UNITED STATES PATENT AND TRADEMARK OFFICE

APPLICATION NO.	FILING DATE	FIRST NAMED INVENTOR	ATTORNEY DOCKET NO.	CONFIRMATION NO.
10/605,852	10/30/2003	Martin Weiss	20073	2851
23470 7590 09/20/2007 SRAM CORPORATION 1333 N. KINGSBURY, 4TH FLOOR CHICAGO, IL 60622			EXAMINER LUONG, VINH	
			ART UNIT 3682	PAPER NUMBER
			MAIL DATE 09/20/2007	DELIVERY MODE PAPER

Office Action Summary	Application No.	Applicant(s)	
	10/605,852	WEISS, MARTIN	
	Examiner	Art Unit	
	Vinh T. Luong	3682

Fig. 3

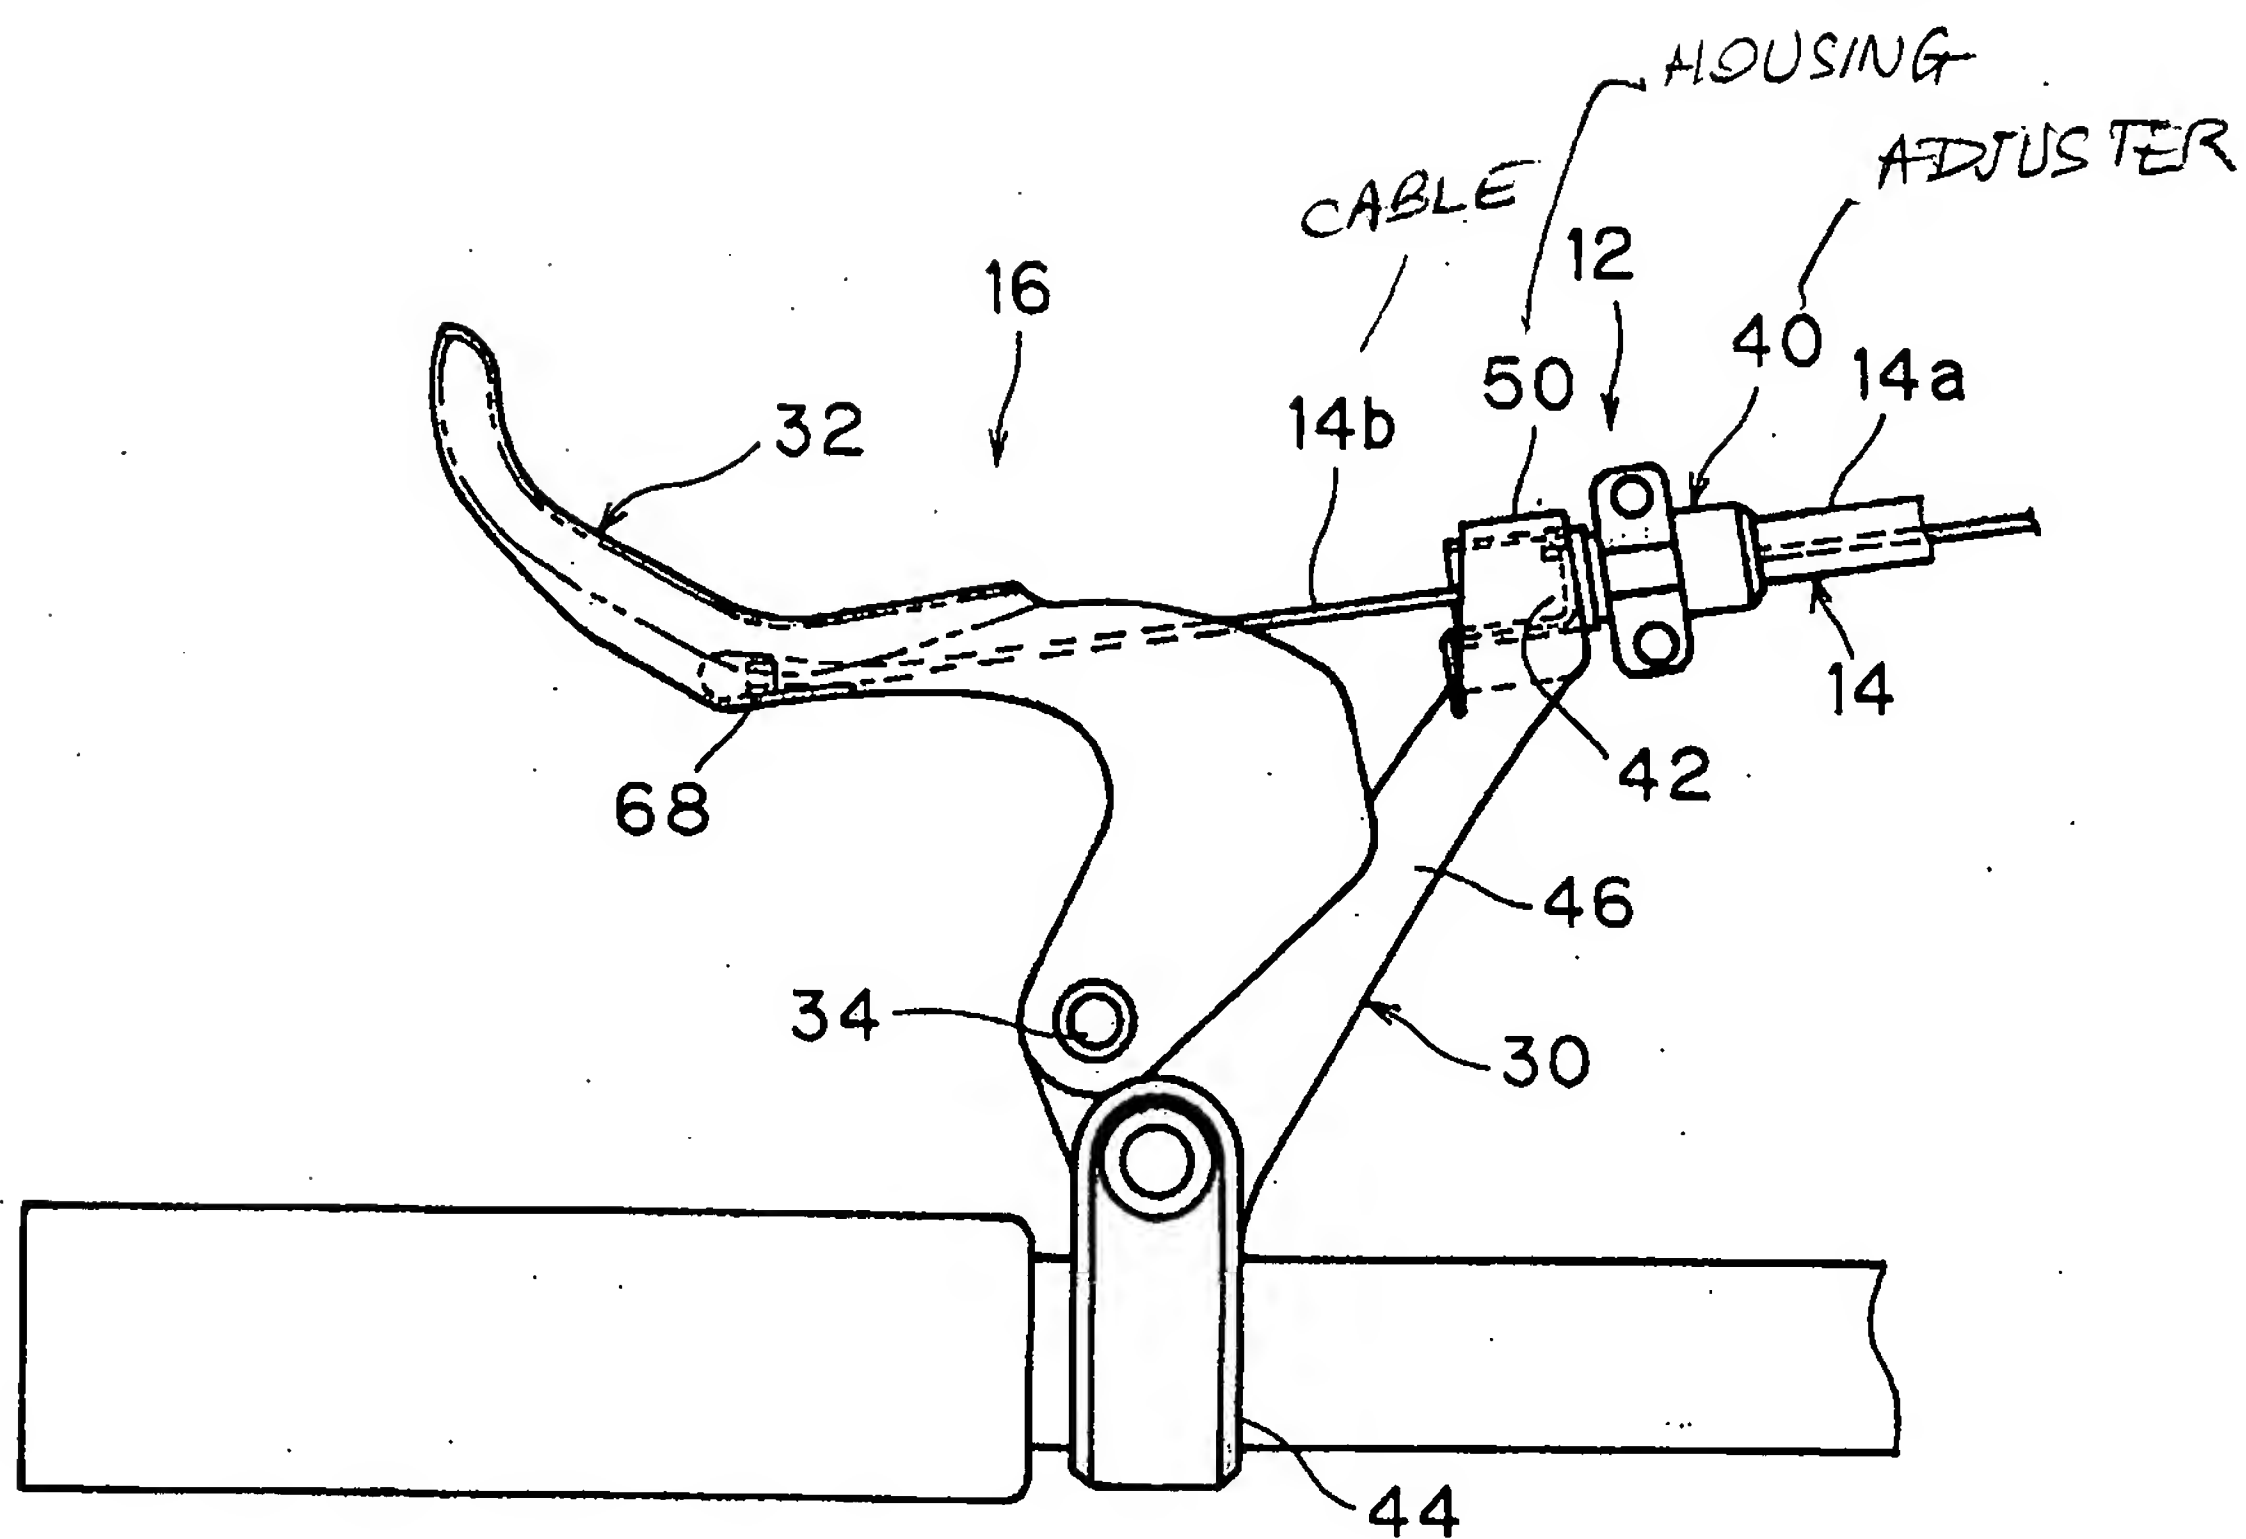
Regarding claim 16, the detent contour 80 has a non-round cross section (FIG. 5) and is configured such that the retention segment 95 has freedom to deflect, the retention segment 95 is

configured to extend substantially parallel with the control cable 14b extending through the adjuster 40 (see FIG. 3 in Att.).

Fig. 5

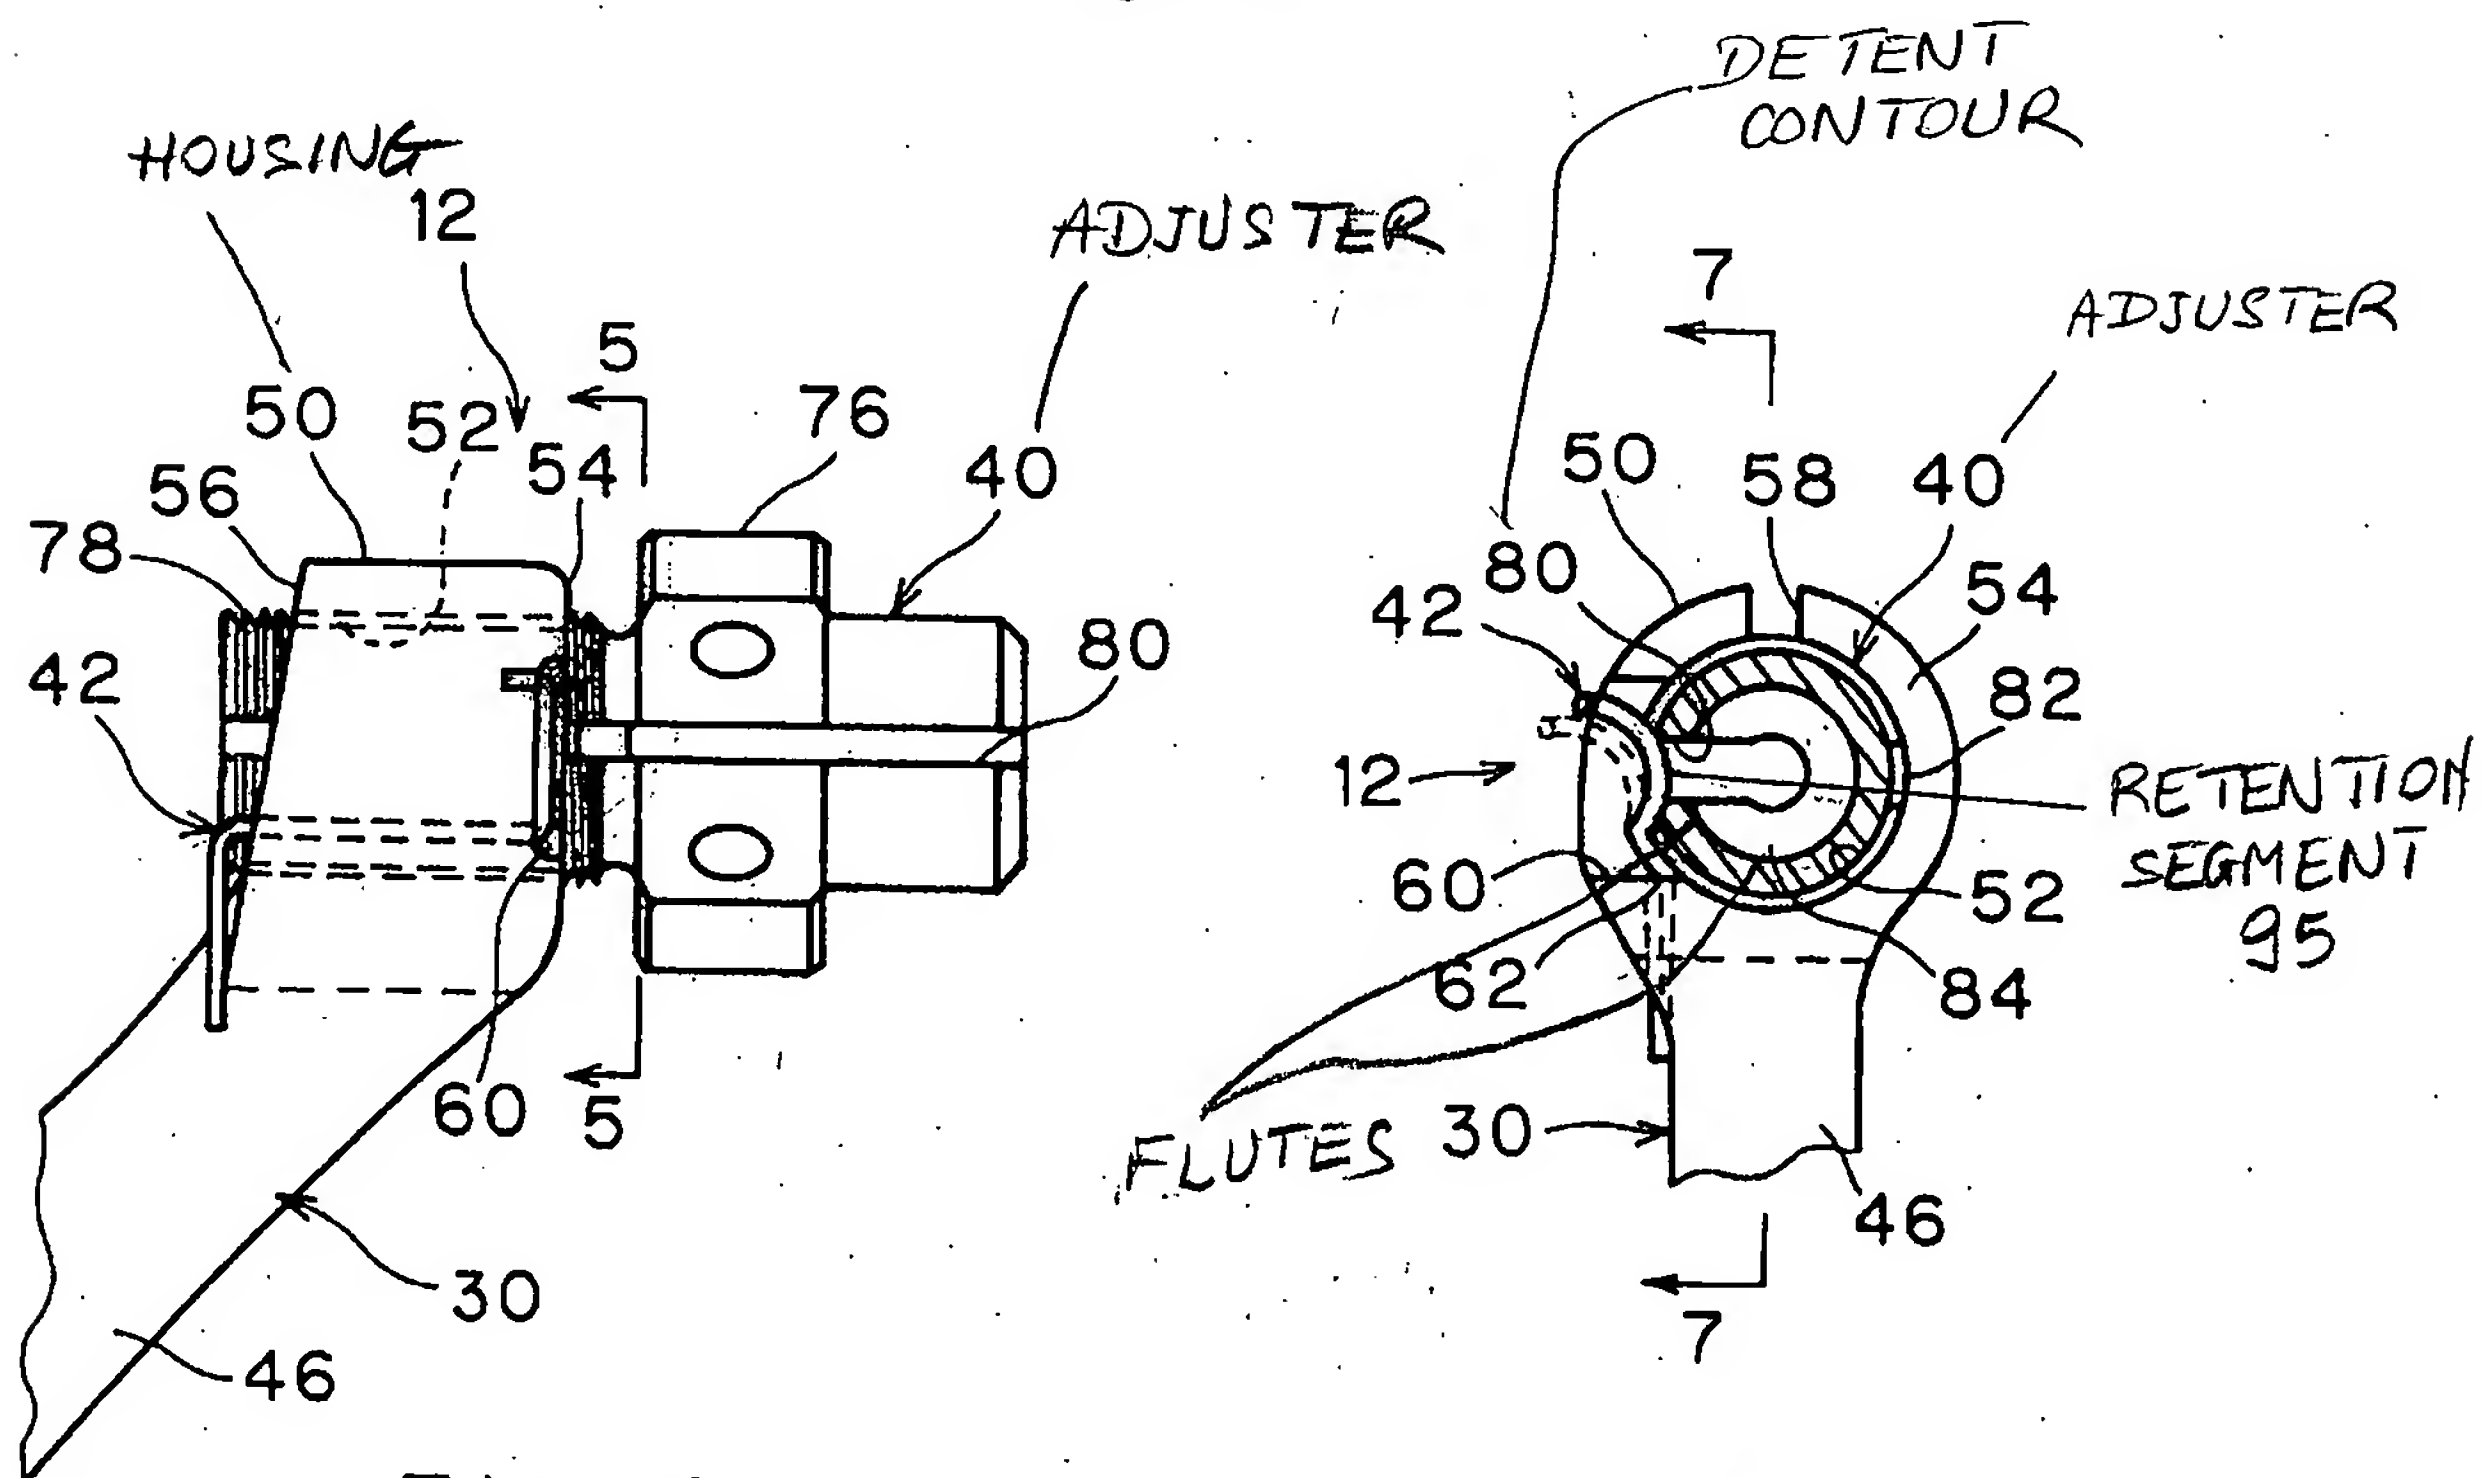
a detent mechanism including a *partially* radial interior detent contour 80 (*id.* col. 5, lines 18-30. See Attachment hereinafter “Att.”) extending axially within the bore 70 and a spring element 42 having at least one retention segment 95 (FIG. 10) *partially* extending axially within the bore 80 (FIG. 5) and a support segment 93, the retention segment 95 of the spring element 42 engaging the detent contour 80 from within the contour 80 (FIG. 5, *id.* col. 5, lines 25-30 and col. 6, lines 53-64), the support segment 93 of the spring element 42 supported by the housing 50 (FIG. 4). *Ibid.*, claims 1-17.

Regarding claim 17, the detent contour 80 includes varying surfaces (FIG. 5) configured to engage the retention segment 95 such that rotation of the adjuster 40 in a first direction inherently requires a higher rotational force than rotation of the adjuster 40 in a second direction.

Fig. 7

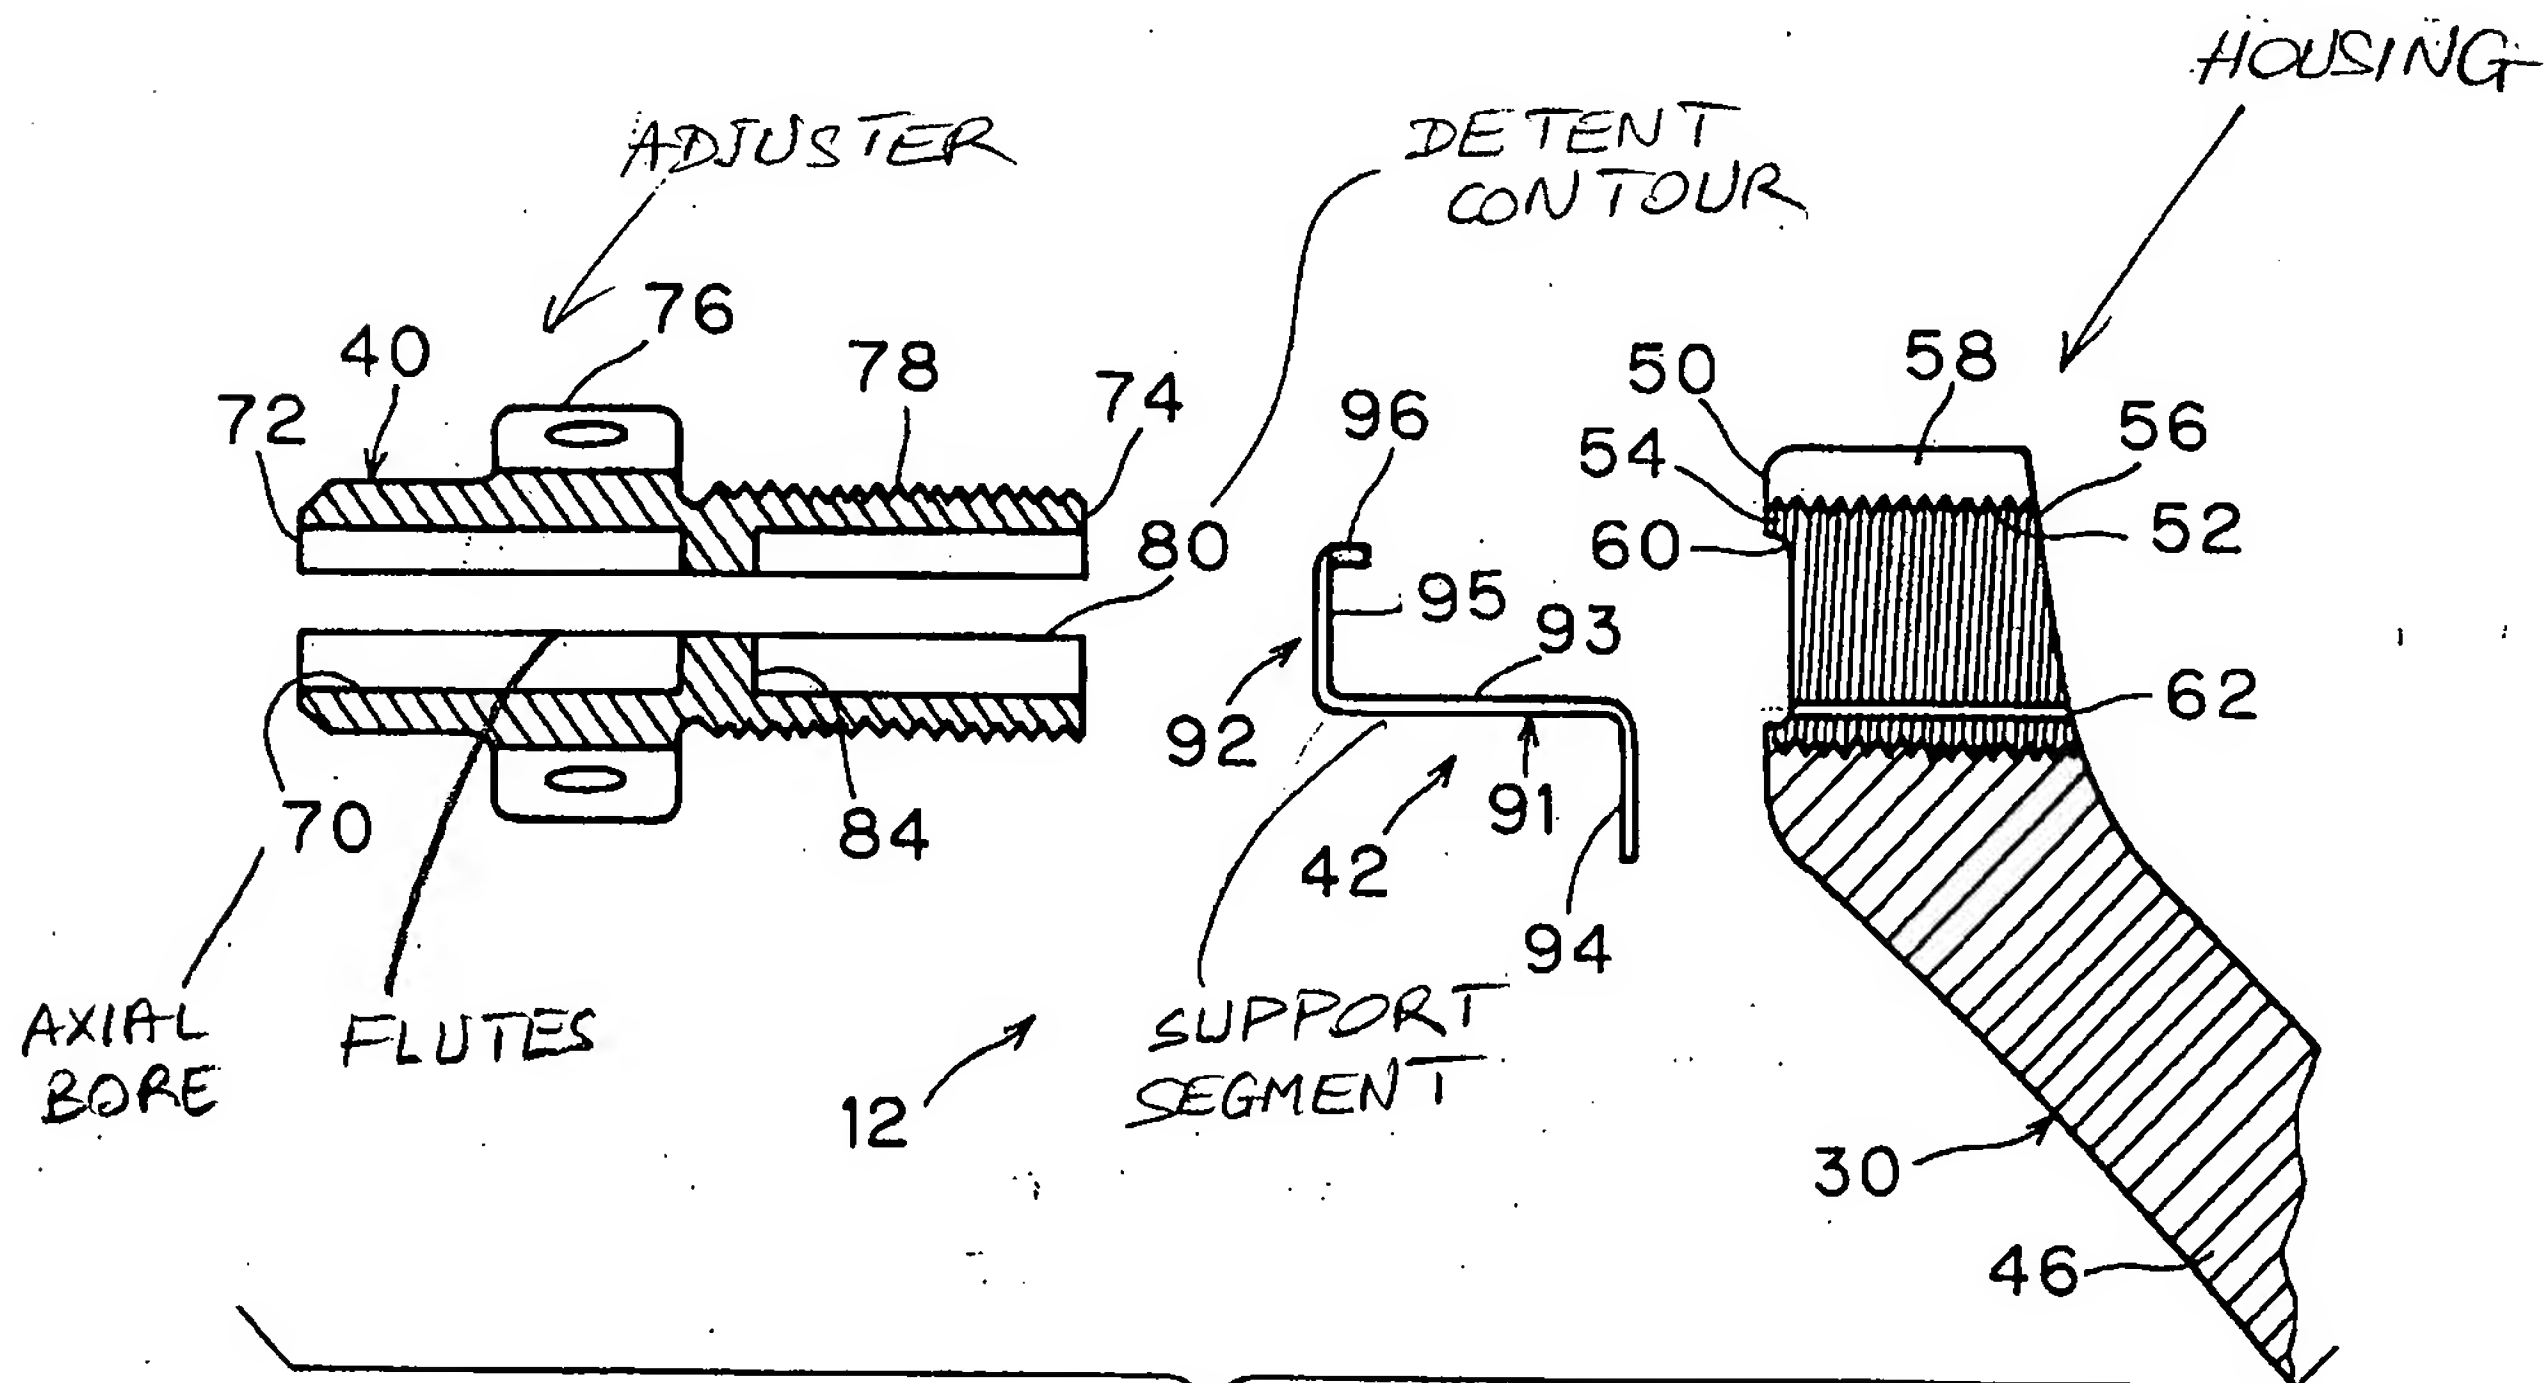
an adjuster 40 having an axial bore 70 (FIG. 7. *Ibid.* col. 4, line 58+), the adjuster 40 rotatably connected to a housing 50 of the control mechanism 16 such that the adjuster 40 is axially moved relative to the housing 50 in response to rotation of the adjuster 40; and
